**TOWN OF HERNDON, VIRGINIA
PLANNING COMMISSION PUBLIC HEARING AGENDA
MARCH 25, 2019
HERNDON COUNCIL CHAMBERS BUILDING
765 LYNN STREET
7:00 P.M.**

Subject: Proffer Condition Amendment Application, PCA#19-01, 525 Grove Street

RE: Vertical Bridge US-VA-5060 – Herndon Substation
525 Grove Street
Proffer Condition Amendment #19-01 - **Revised**

PROFFERS**“Generalized Development Plan, US-VA-5060 Herndon Substation”****PCA #19-01****Amendment to ZMA-02-102****February 26, 2019**

Z-1
SHEET 2 OF 7

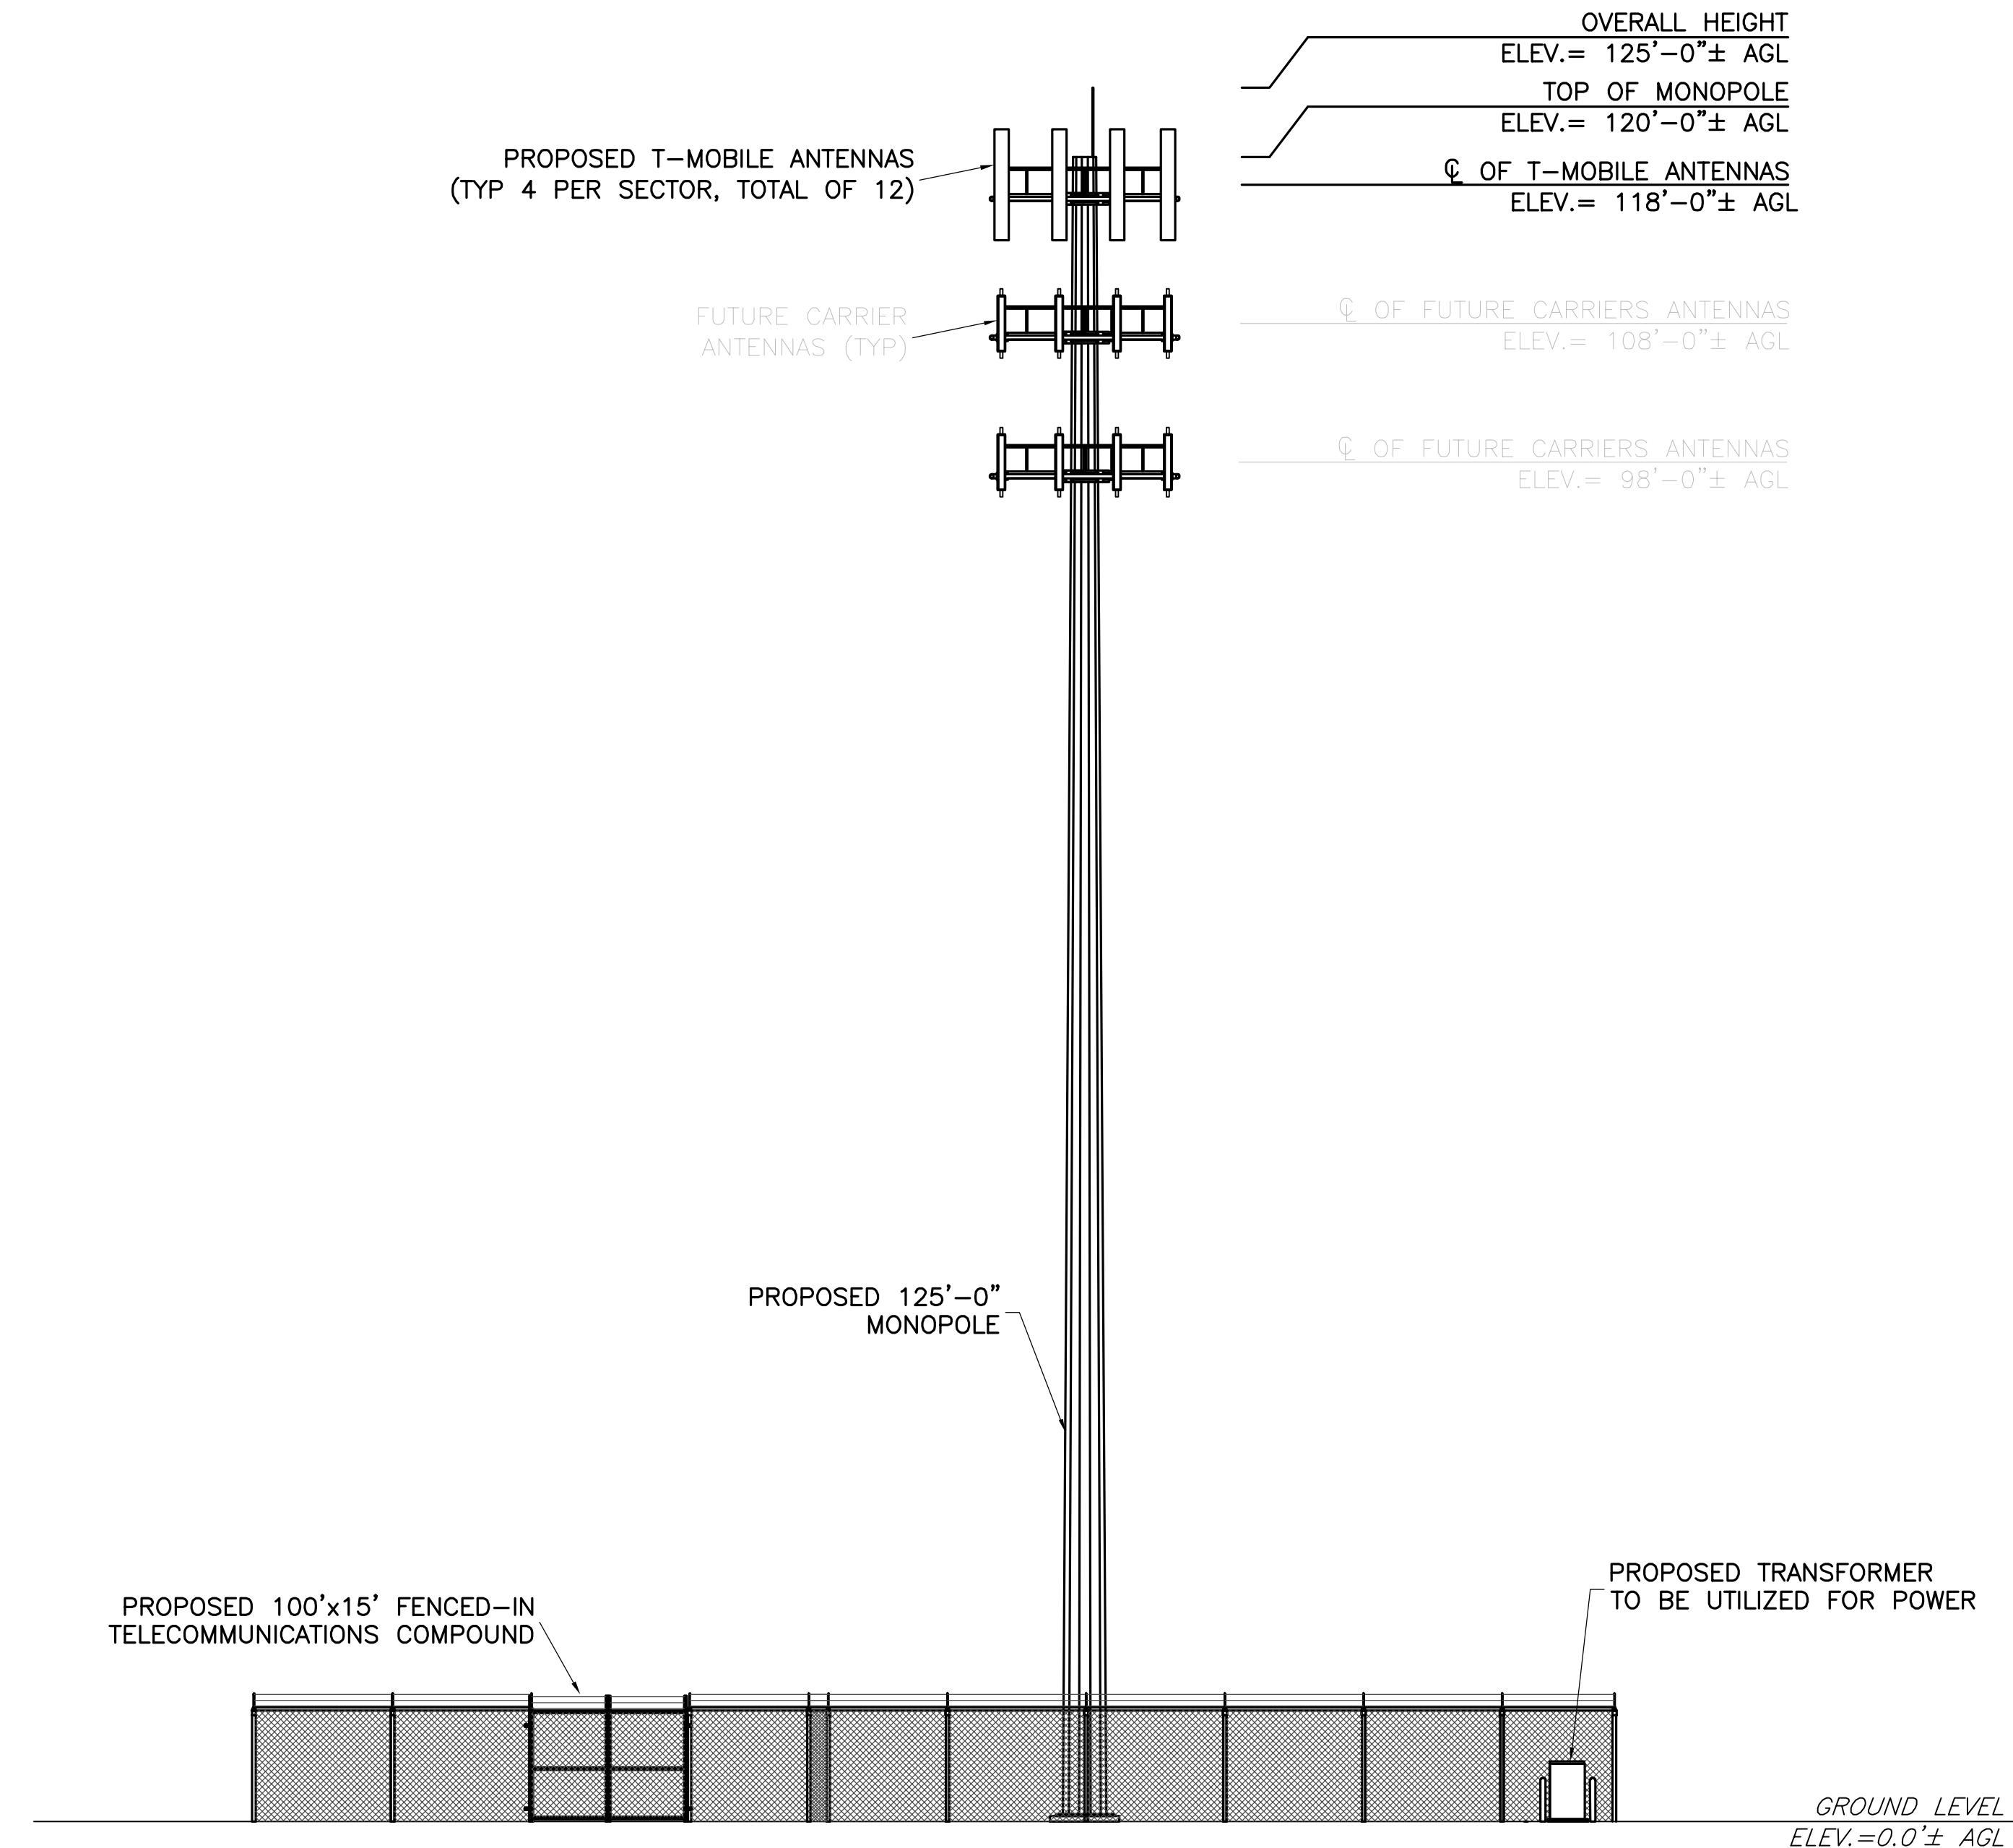
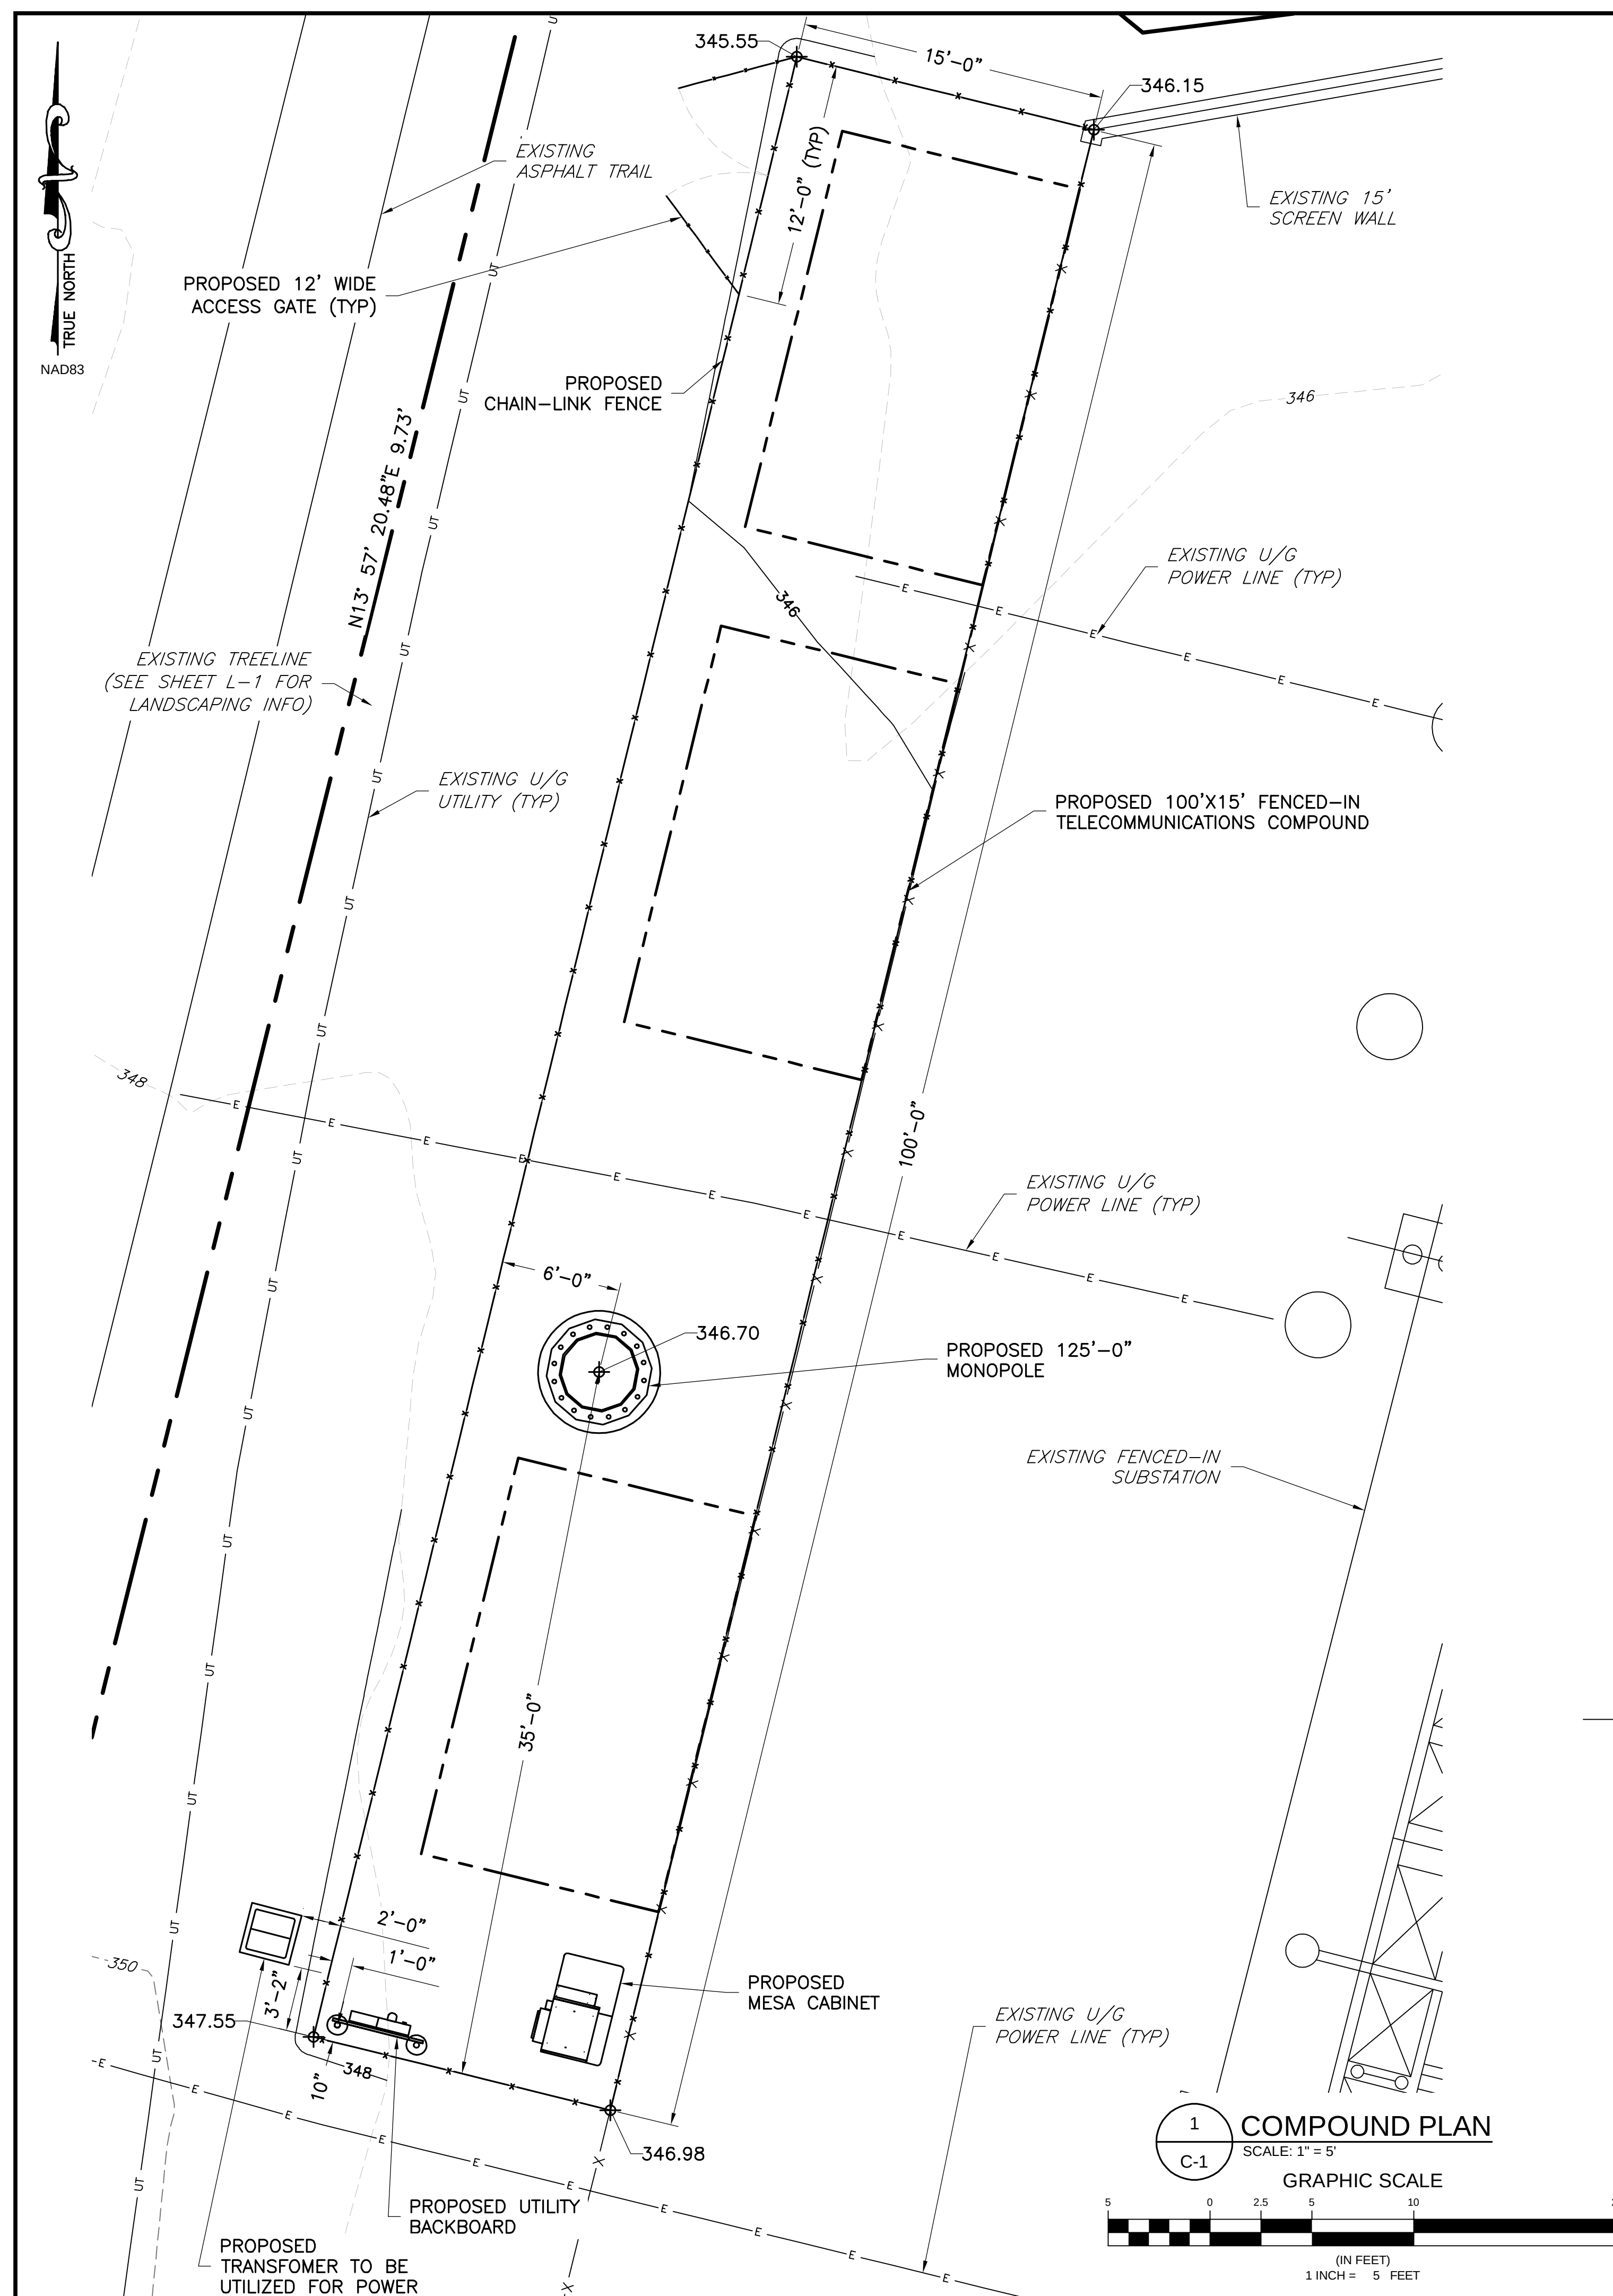
6. Proffer should be added stating that access to the telecommunications compound will only be through the substation site and not the existing trail.

11. The proposed 10' easement for 24/7 ingress/egress located along the western property line near the existing stormwater BMP is within a required perimeter landscape buffer landscape (Section 78-110.4). The plan cannot show improvements not in compliance with the zoning ordinance. A modification may be requested as part of the proposed PCA. If submitted staff will carefully review and consider the loss of landscape screening which is today very effective.

Applicant does not believe this proffer is necessary because the plans have a label indicating that vehicular access is limited to the gravel driveway along the north side

of the property, prior to where it connects to the pedestrian walkway on the west side of the property. Additionally, two bollards have been added to the plans at the west end of the gravel driveway to ensure that vehicles cannot drive onto the pedestrian walkway.

A modification request has been submitted, asking for approval to allow the 10' easement within the required landscape buffer. Please see the enclosed letter with justification statement.
